Site photographs

Delegated Report		Analysis sheet	Expiry Date:	19/06/2018
(Members Briefing)		N/A / attached	Consultation Expiry Date:	02/12/2018
Officer			Application Number(s)	
Elaine Quigley			2018/2342/P	
Application Address			Drawing Numbers	
6 Albert Terrace London NW1 7SU			See draft decision notice	
PO 3/4	Area Team Signature	C&UD	Authorised Officer Signature	
Proposal(s)				
Excavation to lower the lower ground floor of the existing house and excavation of a new lower ground floor level under the front and side gardens, demolition and rebuild a section of the boundary wall on the north west elevation fronting Regent's Park Road and installation of air handling units at lower ground floor level all in association with the existing single family dwelling (Class C3 use).				
Recommendation(s):		Grant conditional planning permission subject to s106 legal agreement		
Application Type:		Householder Application

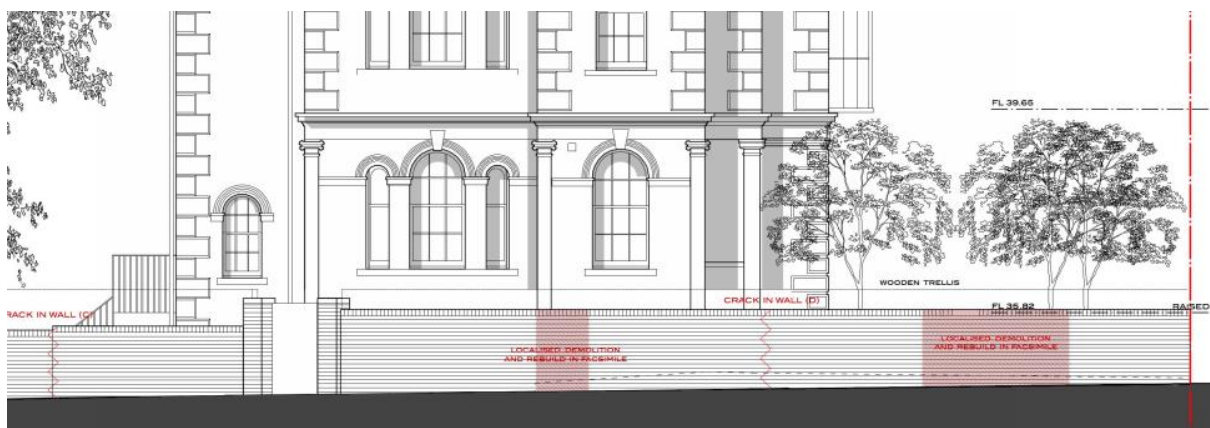
3. Northern side elevation of the house fronting onto the junction of Albert Terrace and Regent's Park Road (above). One magnolia tree and two cherry trees (Category C trees) behind the boundary wall to be removed as part of the proposal.

Figure 1 (above): Extract from planning application 2017/2819/P (refused) showing the basement floor level below the existing lower ground floor level

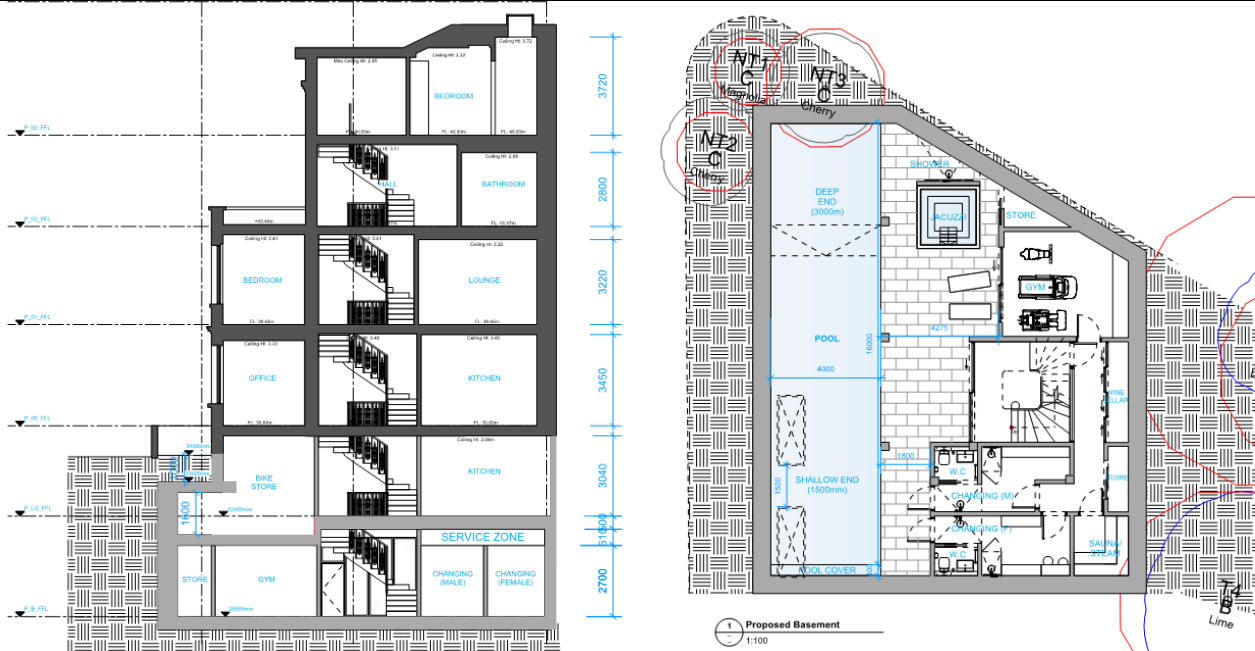
- 2.2 The Inspector in his appeal decision dated 11th July 2018 (APP/X5210/W/18/3192767) agreed that the existing lower ground floor was both quantitatively and qualitatively substantially below the surrounding ground level and would be considered a basement. Consequently the provision of another storey below this resulted in the property having a basement of two storeys.

- 2.3 The Inspector concluded that the extension would result in the property having a substantial two-storey basement, which would be disproportionate, and not subordinate, to the main house and was considered harmful to its character. He confirmed that the proposal failed to accord with Policy A5.

Figure 2 (above): Existing lower ground floor (left) and proposed lower ground floor (right)

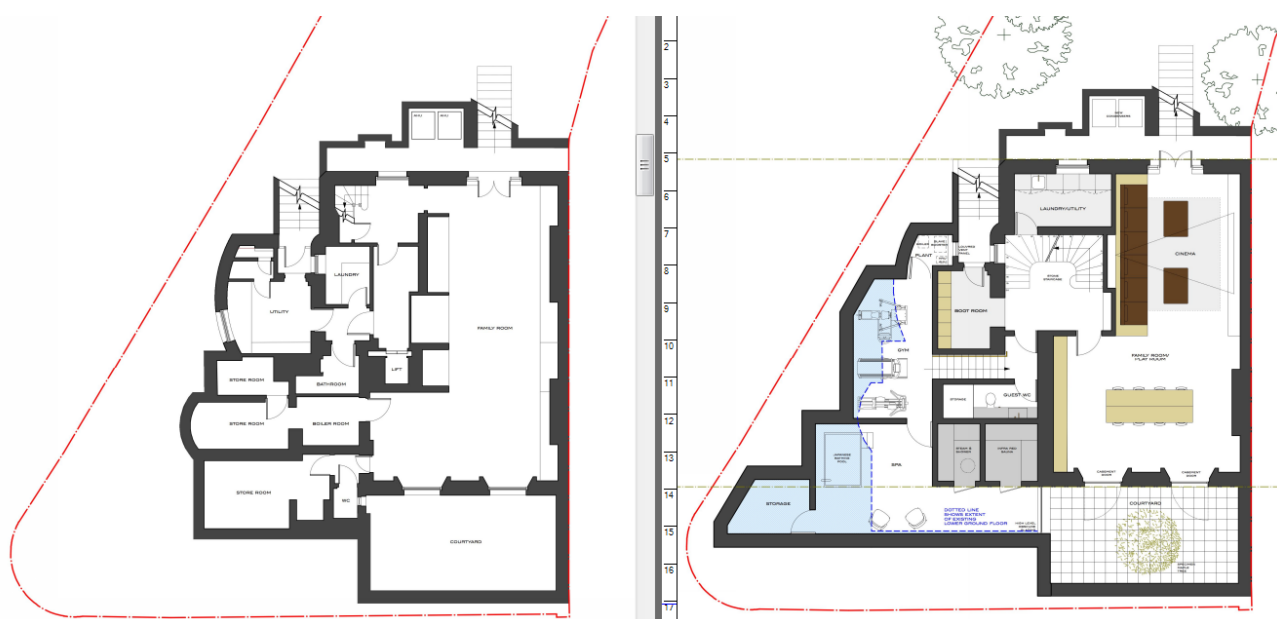
6.3 The proposed lower ground floor would be extended to the side of the existing lower ground floor by between 1.33m and 5.76m. It would be 2.6m deeper than the floor level of the existing lower ground floor but would not be located directly underneath this floor level as it would extend to the side under the existing front and side garden. The basement would be 4m in height with 1m of topsoil on the top (5m below ground level). The proposed works would increase the existing lower ground floor footprint of 167 sq. m by 33 sq. m (GEA). This would represent an overall increase in the lower ground floor by approximately 19.7%. It would create an additional storage area, Japanese bathing pool and gym (see figure 2 below).

Figure 3 (above): Existing building lines of the property identifying what would be front and side and rear gardens (area between the blue lines considered the side garden).

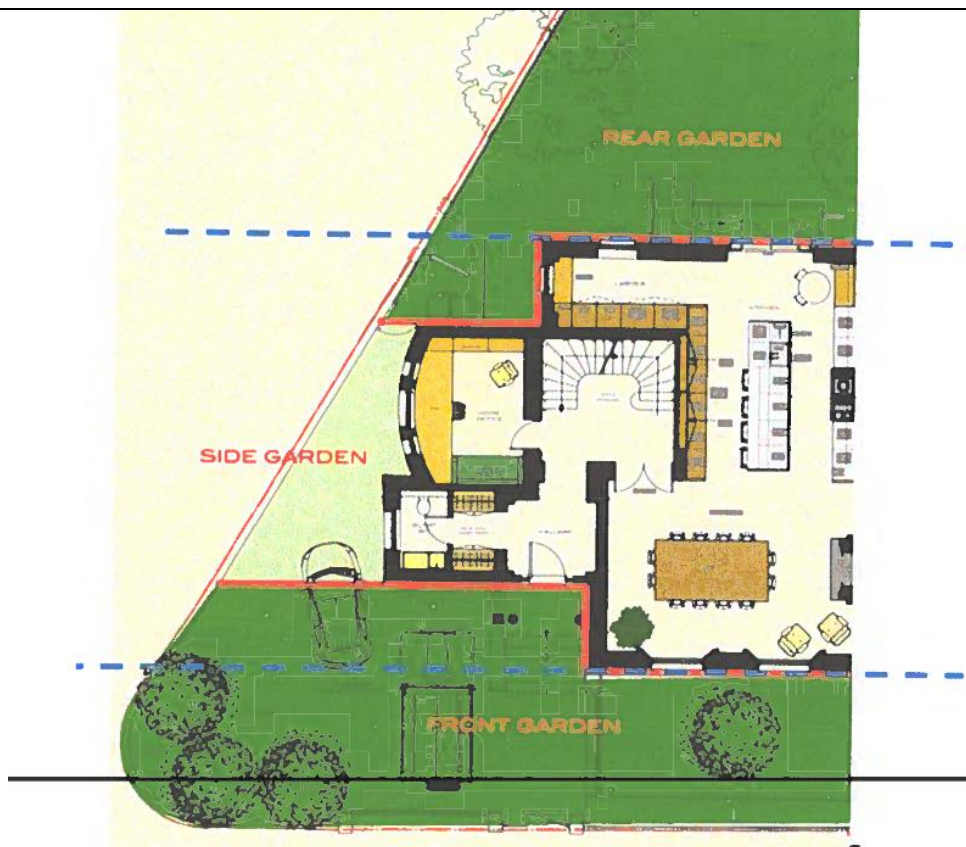
6.7 It would have a 0.5m setback from all boundaries and would extend underneath the existing front and side garden area. Although the setback in this case is small, the policy objective is to provide significant space free from basement development to enable water drainage and area for planting which the proposal would achieve. The CAAC has raised concerns about the extent of the basement into the front/side gardens. The definition of what is the front, side and rear garden is not clearly defined in CPG Basements. However, figure 3 below helps to identify what would be considered the front, the side and the rear garden of the property.

- 6.8 The existing front, side and rear garden areas would measure 91 sq. m, 54 sq. m and 153 sq. m respectively. The proposed extension of the lower ground floor would measure 25 sq. m into the front garden (27.5%), and 27 sq. m into the side garden (50%). The rear garden would remain unaffected by the proposal. This would comply with the criteria A5(h).
